CPED STAFF REPORT

HPC Agenda Item #2
 January 6, 2015
 BZH-28458

Property Location: 300 Washington Avenue North
Project Name: The George Henry Hotel
Prepared By: [Lisa Steiner](#), City Planner, (612) 673-3950
Applicant: 300 Washington Ave LLC
Project Contact: Alex Haecker
Ward: 3
Neighborhood: North Loop
Request: To rehabilitate the existing building, convert it into a hotel with retail and restaurant uses, and construct a rooftop addition.

Certificate of Appropriateness	To allow the rehabilitation of an existing building, conversion into a hotel with associated retail and restaurant uses, and construct a rooftop addition in the Warehouse Historic District.
---------------------------------------	---

PROPOSED SOUTH ELEVATION AND WINDOW KEY

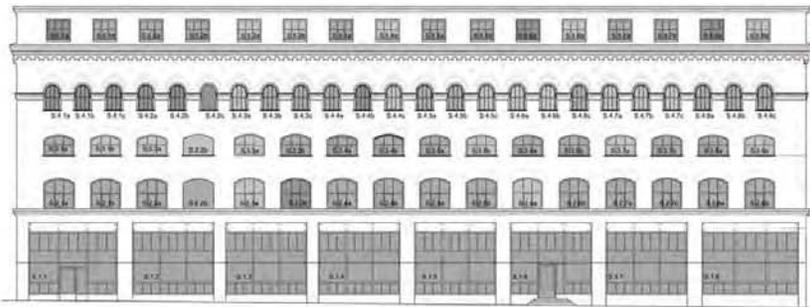
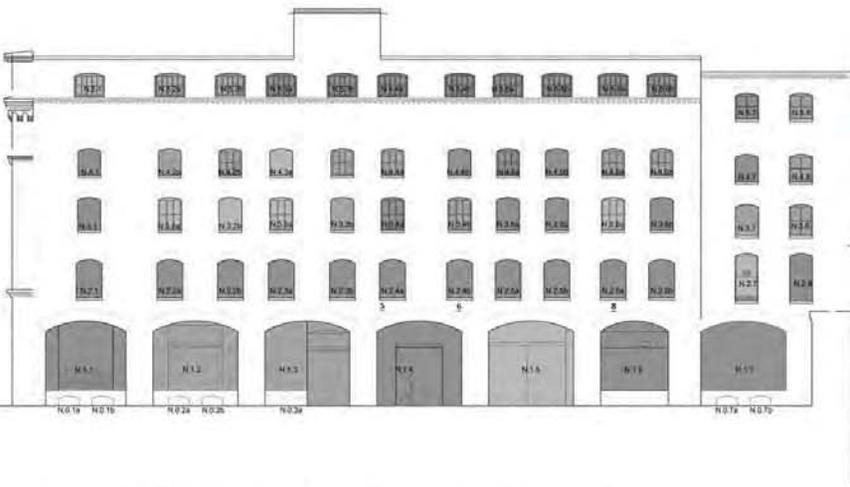
The applicant is proposing to replace all windows on the north and west elevations with “replica” aluminum double-glazed windows. The applicant has submitted a window survey which indicates that the majority of the existing windows on these elevations to be removed are in either “poor” or “very poor” condition. However, a few windows to be replaced are still in “fair” condition.

The replacement windows are proposed to be “low-e insulated glass” but the applicant has not indicated whether the glass will be clear and transparent. Staff recommends a glass sample or specification sheet be submitted to CPED and that reflective or tinted glass shall not be permitted.

11. A material sample or specification sheet for replacement glazing for the rehabilitated windows and the glazing of the replacement windows shall be submitted to CPED for approval prior to the issuance of a building permit.

PROPOSED NORTH ELEVATION AND WINDOW KEY

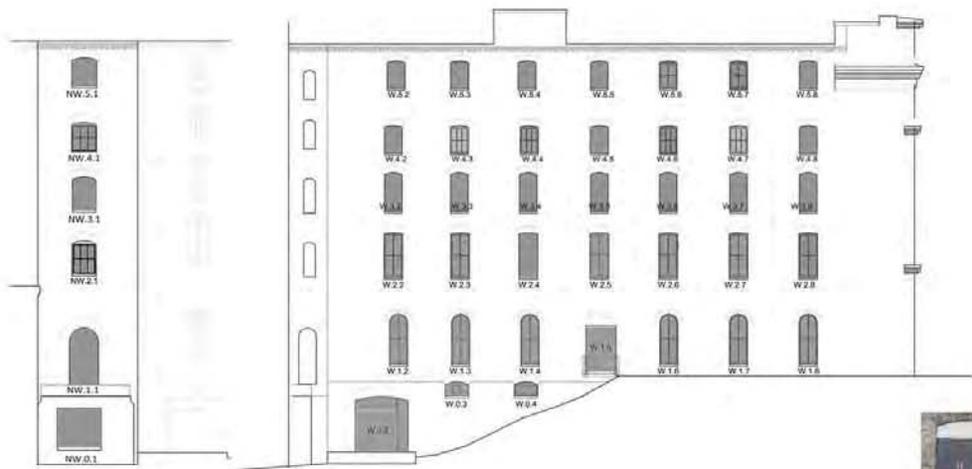
On the north elevation, the applicant is proposing to remove one historic wooden loading door to accommodate mechanical louvers. The window survey notes that this door is original and remains in fair condition, requiring only minimal rehabilitation. This proposal does not meet the requirement guidelines and would not retain an original and historically significant loading door. The location of the doors here shows that the alley was utilized for loading purposes historically, either accessed by the street or the railroad, likely before the Colonial Warehouse addition at the west end of the alley was constructed. Staff recommends that these doors be maintained and preserved in place and that any mechanical louvers shall be located in openings where original doors do not remain in place.

JACKSON BUILDING
CERTIFICATE OF APPROPRIATENESS APPLICATION
PROPOSED SIXTH FLOOR VISIBILITY STUDY

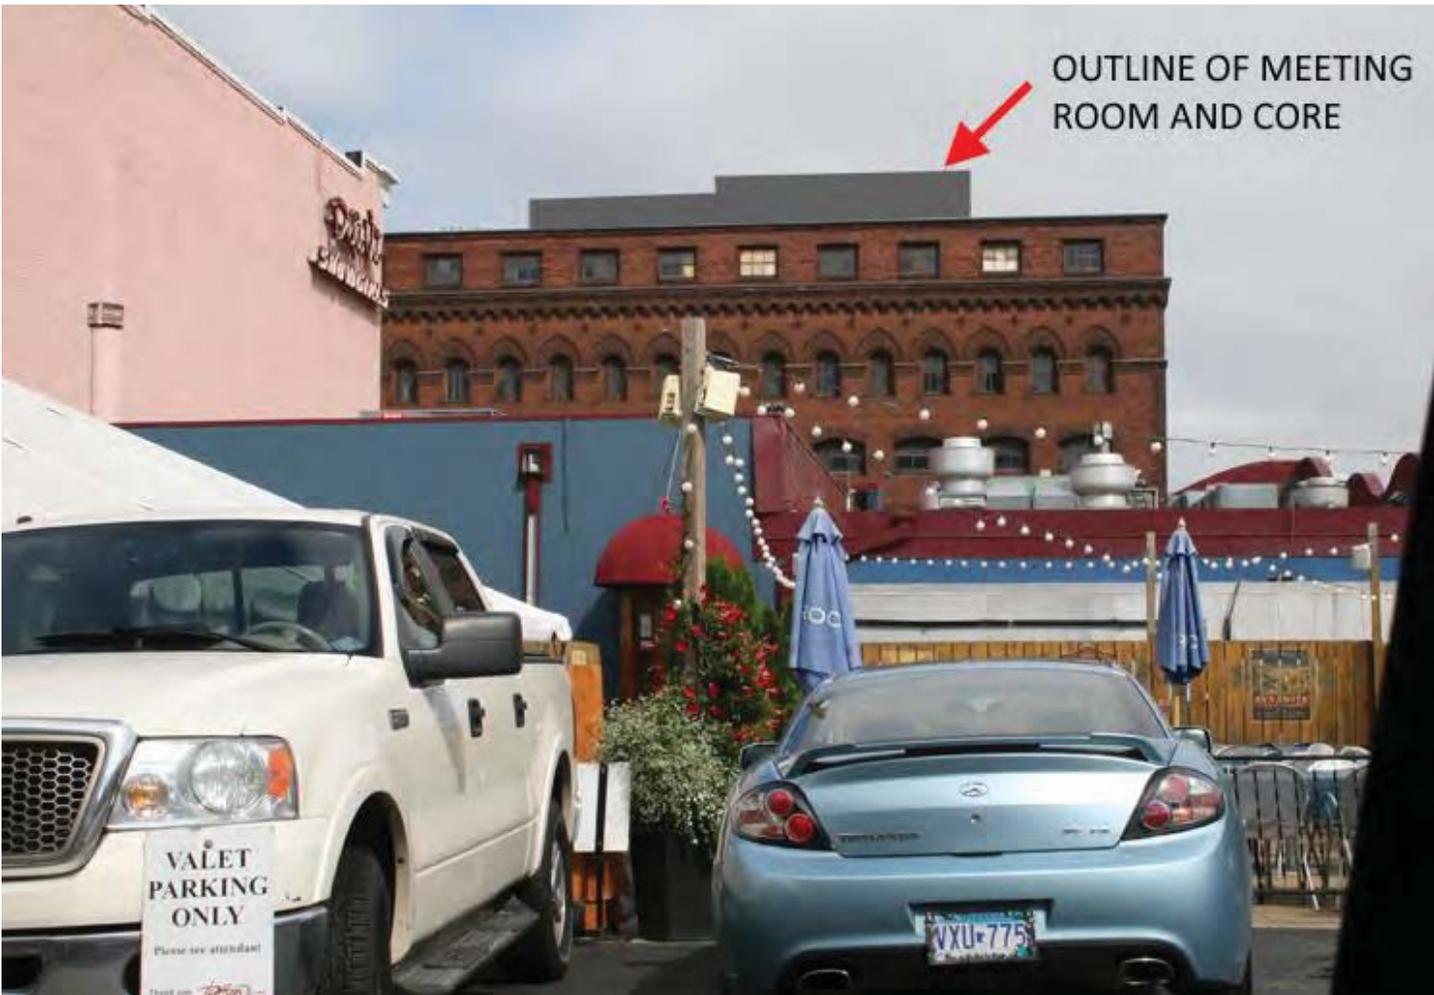
The applicant has submitted a mock-up visibility study of the rooftop addition. However, the mock-up was built based on a different roof plan and is therefore not entirely accurate. It does, however, demonstrate the visibility of any structure of the proposed height on the building, and is provided for reference in the appendix.

Exterior Repairs

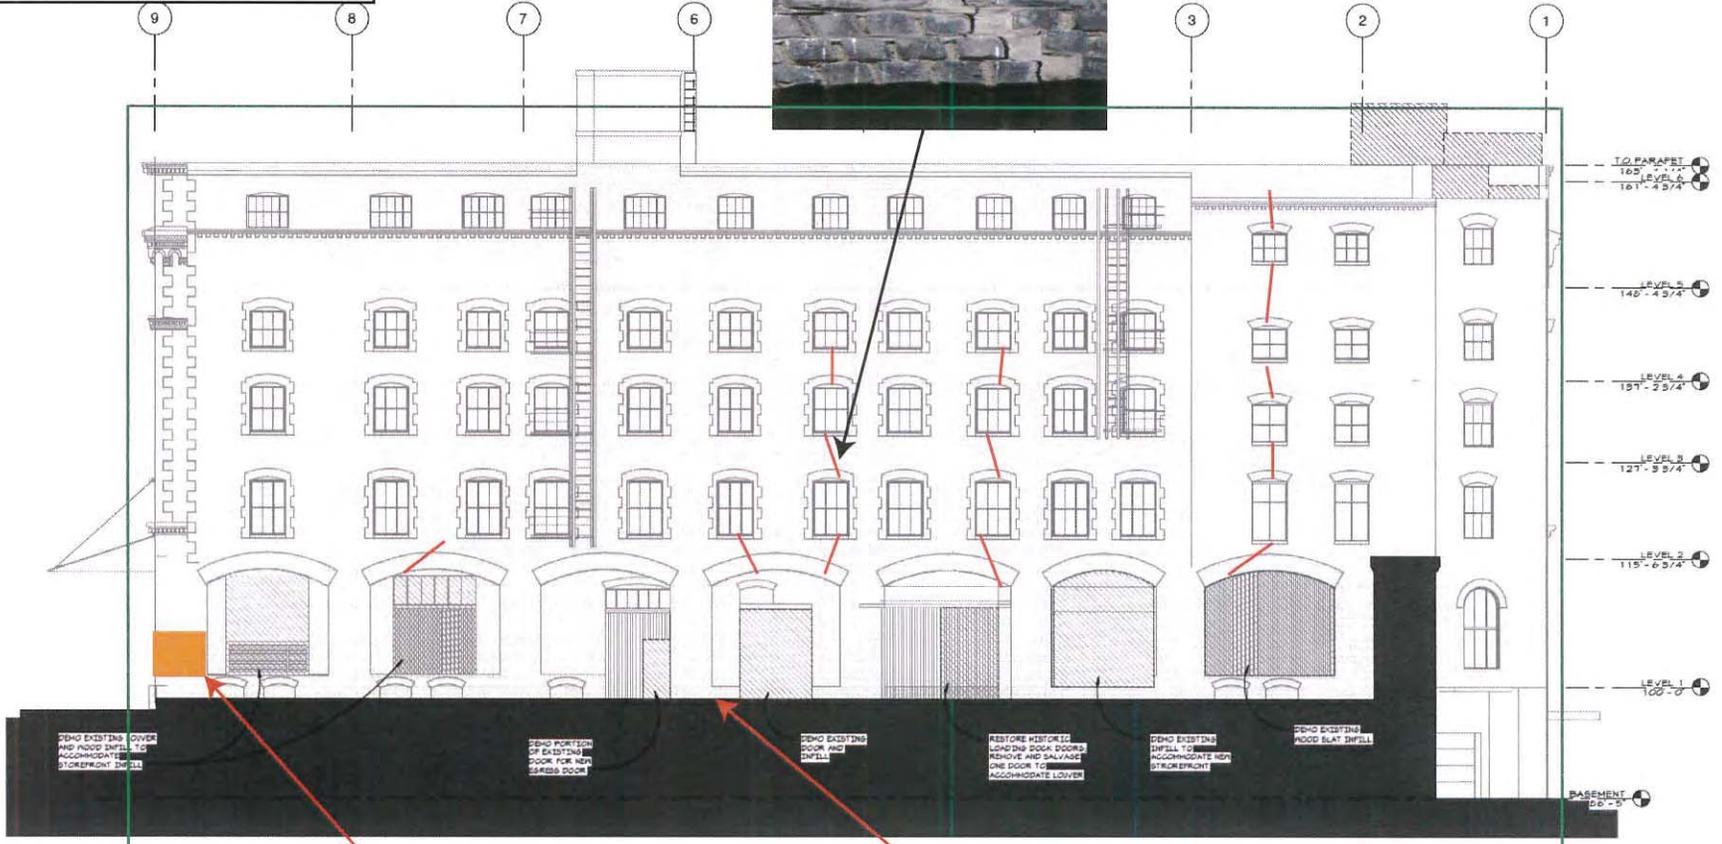
The masonry restoration proposal submitted does not include detail regarding the replacement bricks or mortar, or whether hand or electric tools will be used to clear mortar. The proposal recommends removing paint but does not propose a method for doing so. Staff recommends that a full masonry plan, signed by an engineer, be submitted to CPED for approval prior to the issuance of a building permit, which demonstrates that all the requirement guidelines for façade materials (2.12 through 2.19) are met. Any use of chemical treatments to remove paint or tar staining will require an agreement with CPED to test a small area and then review the results.

7. Mortar joints shall be cleared with hand tools. The use of electric saws and hammers to remove mortar can seriously damage the adjacent brick and are inappropriate.

10. Any use of chemical treatments to remove paint or tar staining requires an agreement with CPED to test a small area, review the results, and develop an agreed upon process to complete the cleaning.
